MIL "ON" DTC P0456

Service Category Engine/Hybrid System

Section Engine Control

YEAR(S)	MODEL(S)	ADDITIONAL INFORMATION
2010	Corolla, Matrix	Drive Type(s): 2WD Engine(s): 2ZR Transmission(s): 4AT, 5MT VDS(s): BU4EE, KU4EE

Figure 1. Location of Authorized Modifications Label on 2010 Corolla and Matrix

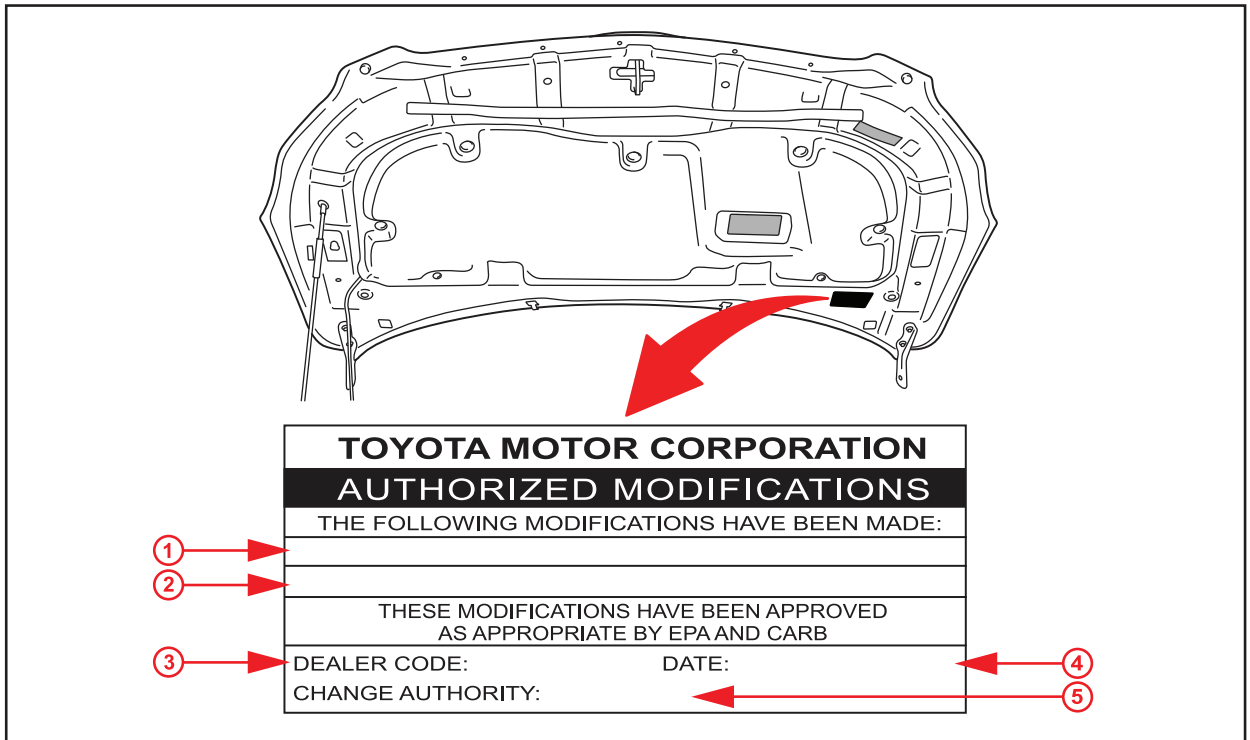
1. Using TIS Techstream, check for stored DTCs. If only DTC P0456 is present, proceed to step 2.
2. Clear DTCs.
3. Confirm that the fuel cap is tight. If it is loose, tighten the cap (this will complete the repair). If the cap is already tight, proceed to step 4.
4. Check for the Authorized Modifications Label affixed to the vehicle in the location shown in Figure 1. Confirm if the ECM (PCM) calibration has been updated. If the calibration ID listed is NOT the latest ECM (PCM) calibration — go to step 5.

- Install the Authorized Modifications Label.
 - Using a permanent marker, enter the following information on the label:
 - ECM part number [Refer to the **Parts Information** section for the **CURRENT PART NUMBER**]
 - Calibration ID(s) [Refer to the **Calibration Identification Chart** for the **NEW CALIBRATION ID**]
 - Dealer Code
 - Repair Date
 - Change Authority [**This TSB number**]
 - Affix the Authorized Modifications Label to the vehicle at the location shown in Figure 1. The Authorized Modifications Label is available through the MDC, P/N 00451-00001-LBL.
- Using Techstream, run the Automatic EVAP System check.
